January 7, 2002

Nunavut Water Board
P.O. Box 119
Gjoa Haven, NU
X0E 1J0

Re: Polaris Mine Decommissioning and Reclamation Plan – Response to Regulator Questions

SECTION - 1200 N
1:1000

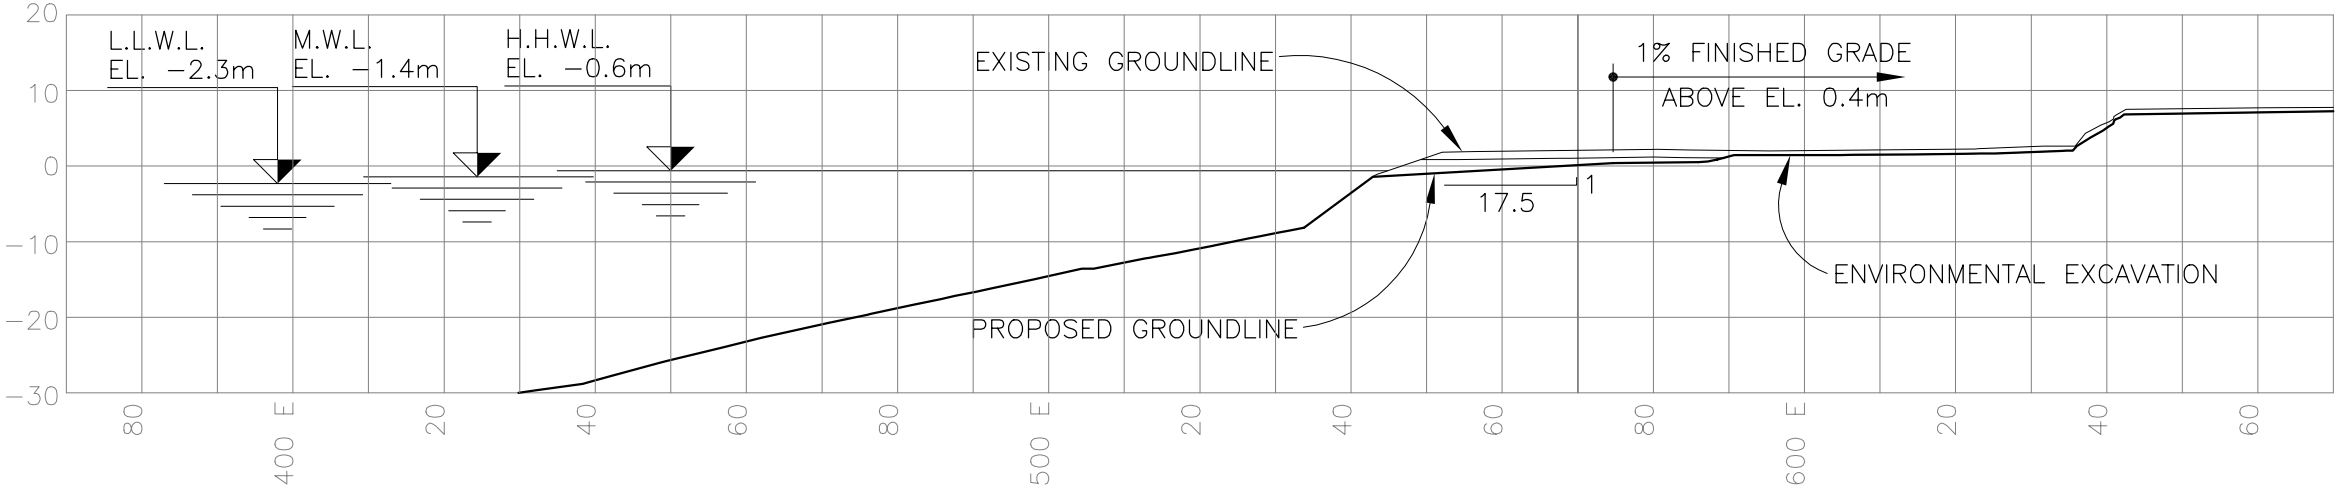
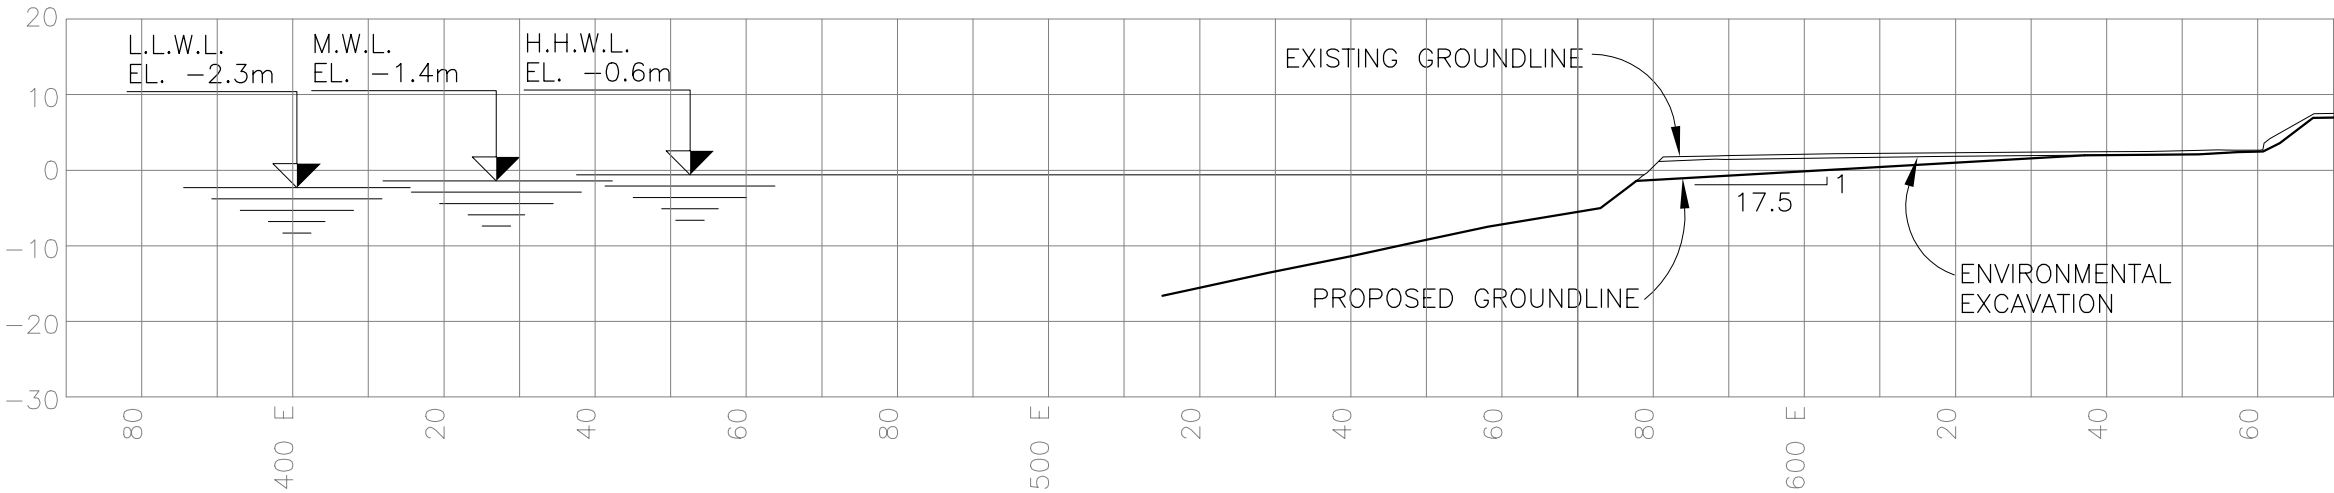
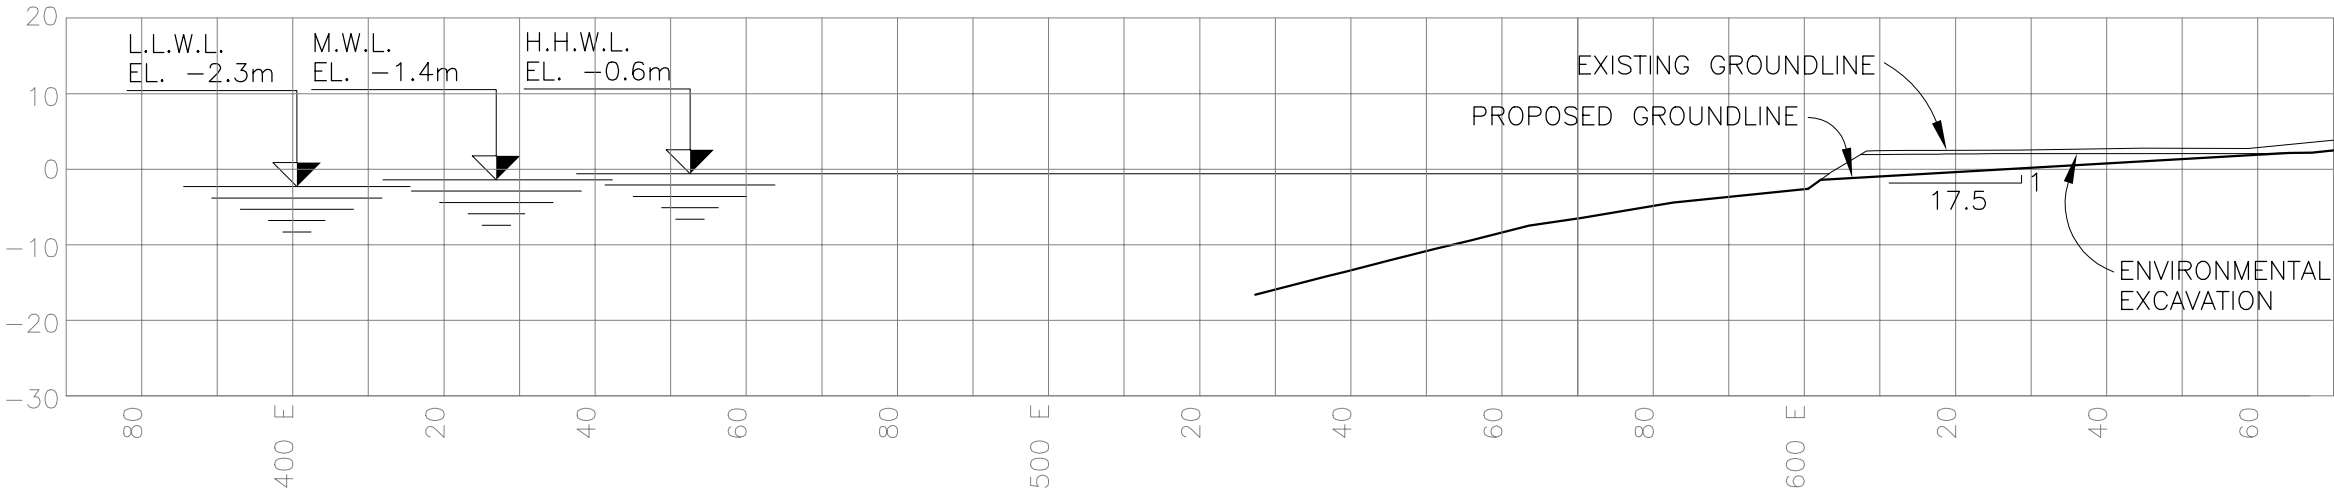
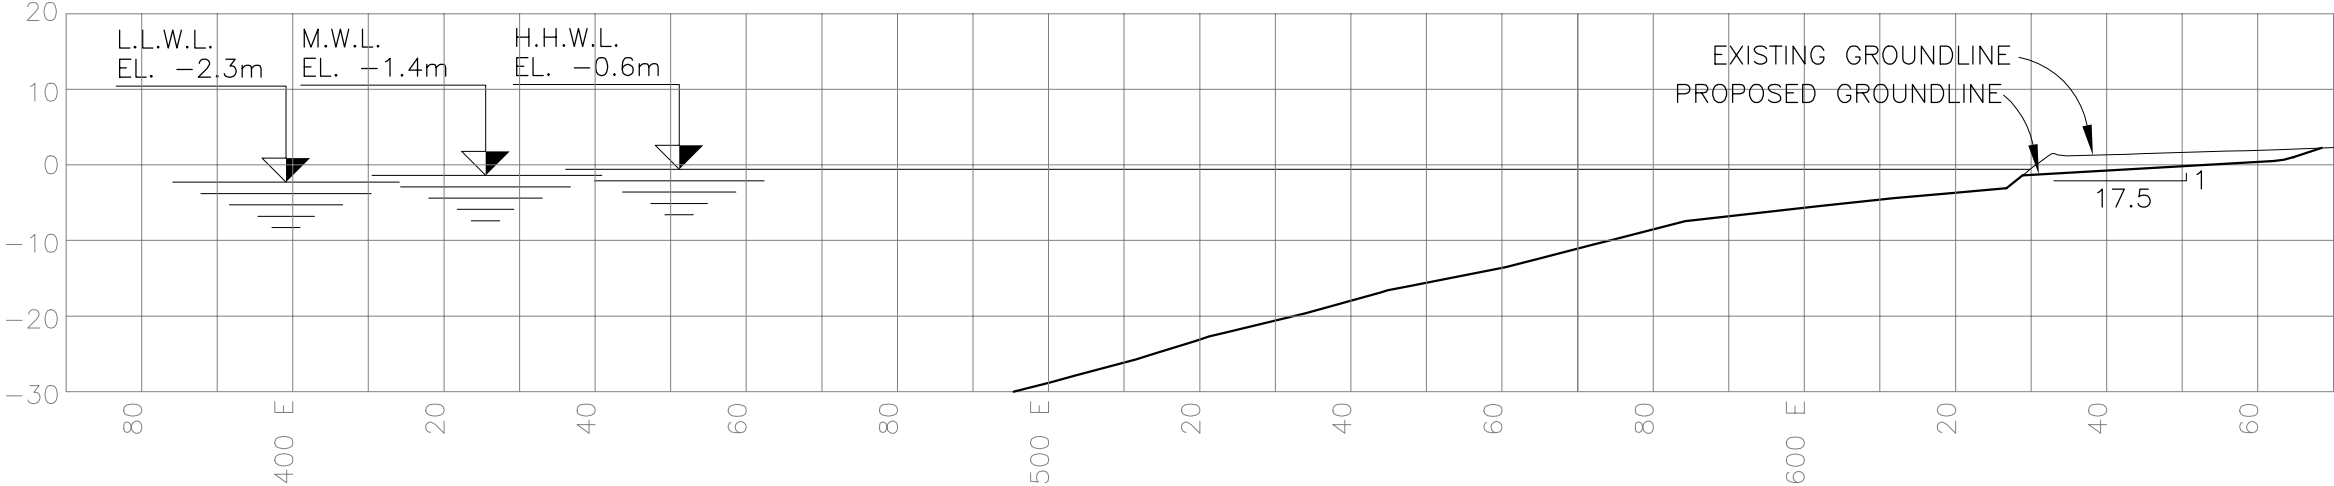
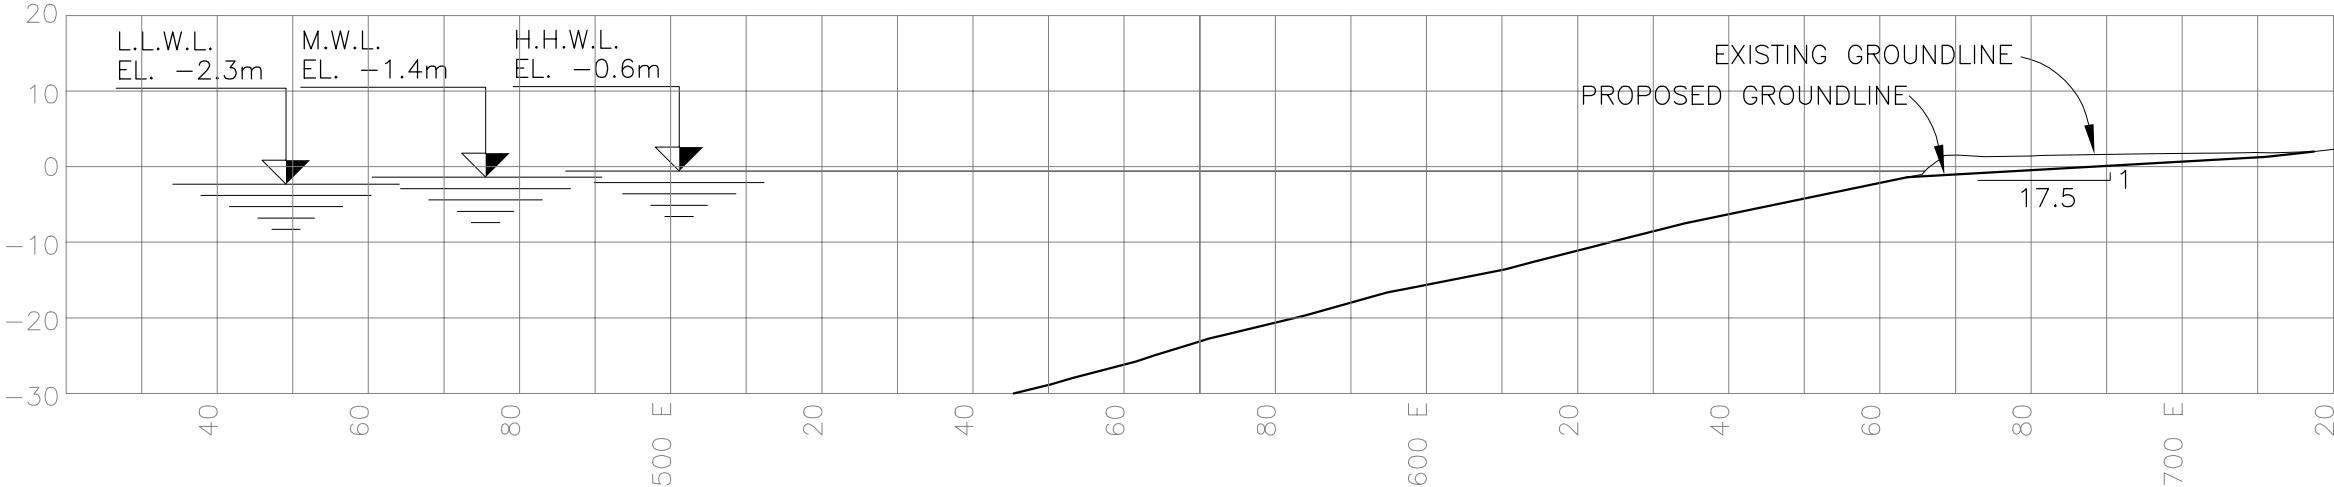
Decommissioning of the Dock - Although plans to remove the dock with recontouring of the shoreline to approximate natural shoreline slope is considered the preferred alternative, additional detailed, finalized construction information and finalized blasting plans are required.

In reviewing the drawings in Appendix D, a significant drop off (approx. 10 m) between the proposed ground-line and the existing ground-line will still exist where the dock sheet piles are presently located (see appendix D - sections sheet 3). The report states...”regardless of whether the sheet piles are cut-off or are extracted, the frozen fill will erode very slowly, and is not expected to have an impact on seabed habitat.” However, because of vertical face of the drop off at this location and since the material in this face (probably) contains fill used in the sheet pile cells, justification as to why this vertical face will experience gradual erosion while other areas are being re-graded to a 17.5V:1H slope should be provided.
